General Information		
Project Name and Location	Winrock phase A Winrock mall Fred Gurena	Ring Road	;
Site Contact Name & Agency	Fred Gurena Winrock Powdners	Contact Phone #/ E-mail	goverz @ governon realty.
Date of Inspection	11-14-16	Start/End Time	40/ 20:50
Inspector Name, COA Dept.	Curtis Cherne	e, Stormwater Quality	
Inspector Phone / E-mail	505-924-3420/ccherne@cabq.gov		
Inspector Qualifications	Qualified Compliance Inspector of Storm	water- Stormwater One	
Describe Present Phase of Construction	Stabilizie		
Type of Inspection: Regular • During store	****	• 311 / Complaint Respo	onse • Follow-Up
	Weather Information		
Weather at time of this inspect	ion? Rain Sleet Fog Snowing	•	perature: ~ 6 F°
Has there been a storm event s	ince the site was Permitted? Yes Now	"	
	Erosion & Sediment Control Ins	spection	新於台灣的高級國際
Entrance / Track-Out	MA	*11-50-41	
 Sediment Controls / Silt F Check Dams, Waddles 	, etc

Winrock Ring Road SWPPP inspection

Winrock Town Center
Sections 2 and 4

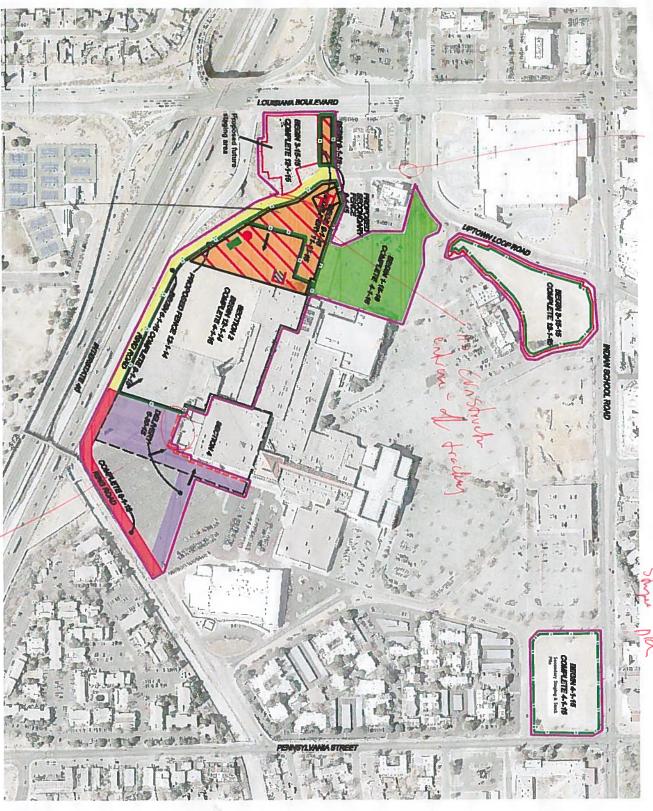
The west side of the site looked really good. What do you call that steel device at the west construction entrance?

At the delivery entrance on the east side there is some sediment in the parking lot. If it is only used for deliveries I understand why you would not want to have a formal construction entrance. However, there was a loader parked over there (see photo).

If primarily used for deliveries, you could leave entrance as-is and just sweep as sediment is tracked-out/relocated into the parking lot.

I would appreciate you getting that area cleaned up.

prox called 6-4-15 - 1:30 gr.

It sike to the east is under Hart Consdruction.

The loader is Mso Hart's.

The spake to the Super and May are print to
restripe within the next week and will sweep
